Re: **Coso Operating Company
CAC-046289
CA-65002005-100**

This letter presents the comments of Little Lake Ranch, Inc. ("LLR"), to the Environmental Assessment prepared by the Bureau of Land Management ("BLM") on the Coso Operating Company Hay Ranch Water Extraction and Delivery System, CACA-046289, CA-650-2005-100 project ("Project"). I am also enclosing a CD on which all of the reference materials cited in the body of this letter, and indexed at the end of this letter, can be found. Please address all of the comments and questions presented below in connection with the Sections noted.

Fig. 4A. Water balance for typical conditions at a double-flash unit at Coso during early operating conditions.

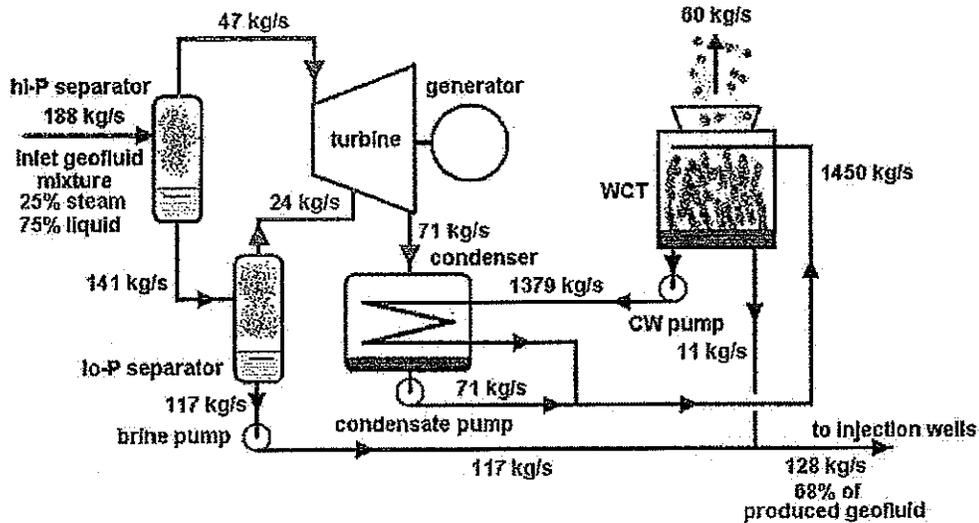
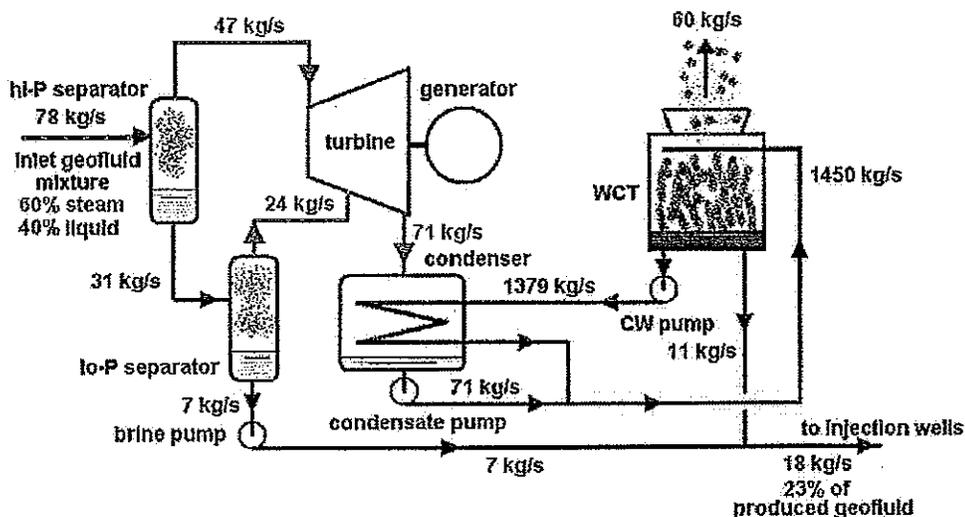
To better appreciate the differences between a WCT system and an ACC system, I refer the reader back to Figures 4A and 4B. In Fig. 4A which represents the early stages of plant operation (say 1990 or so), 188 kg/s of geofluid was produced from production wells per power unit, of which 75% (by mass) was liquid and 25% was steam. Approximately 71 kg/s of steam were condensed to liquid in the condensers and transferred to the WCT along with 1,379 kg/s of cooling water that has just been used to condense the steam. Thus 1,450 kg/s of still hot water is sent to the top of the cooling tower, where some 60 kg/s is lost through evaporation. Thus only 11 kg/s of the steam condensate is then available for injection. The total liquid available for injection is 128 kg/s because the 117 kg/s of brine from the flasher is added to the excess steam condensate. In other words, 68% of the 188 kg/s taken from the reservoir can be returned via injection wells. There is a further water requirement; in order to put the power plant into

Figure 4B shows roughly the state of affairs currently at Coso after the geothermal reservoir has been constantly drying out over the years. The production wells now produce roughly 60% steam and only 40% liquid. For the specified turbine steam requirement, there is a much smaller amount of liquid available for injection. Indeed, whereas initially 117 kg/s of brine would be available to add to the 11 kg/s of steam condensate for injection, now we find only 7 kg/s of brine, and therefore only 18 kg/s or 23% of the produced geofluid mass is available for reinjection.

Fig. 14A. Coso-type plant equipped with a water cooling tower. Nomenclature: Same as Fig. 1 except: HPF, High-Pressure Flasher; LPF, Low-Pressure Flasher; GE, Gas Ejector; CP, Compressor; M, Motor; CN, Condenser; CT, Cooling Tower; P, Pump.

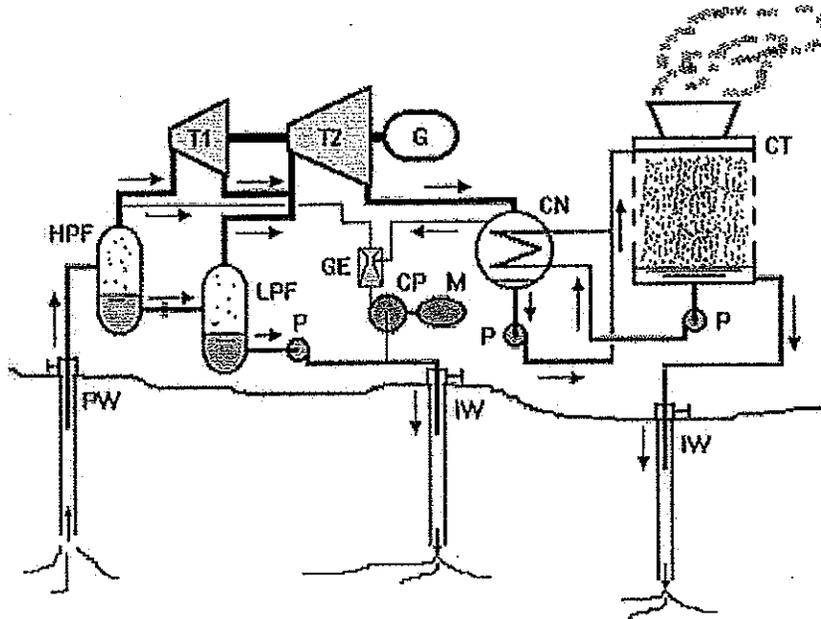
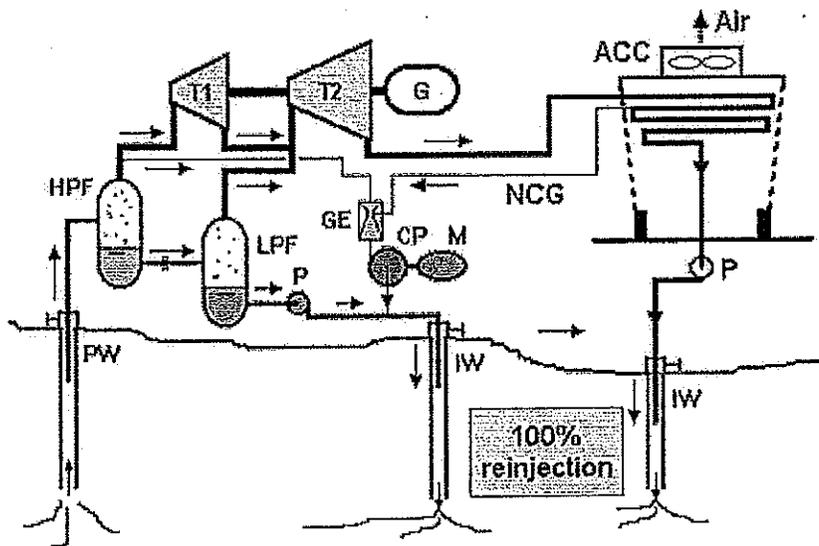
However, it is technically feasible at flash-steam plants, as is illustrated in Figures 14A and 14B which depict a Coso-like plant equipped first with a WCT (Fig. 14A) and then with an ACC (Fig. 14B). Generally, ACC systems are more costly than plants with WCTs because they require more expensive components, and they occupy more land for the same power rating. Nonetheless, the advantages of using an air-cooled system in a facility such as Coso are evident. If alternative sources of water for importation are not reasonably available, then the use of an air-cooled system would reduce, or even arrest the rate at which Coso's geothermal reservoir is drying out, leading to prolonged production and an extended plant lifetime.
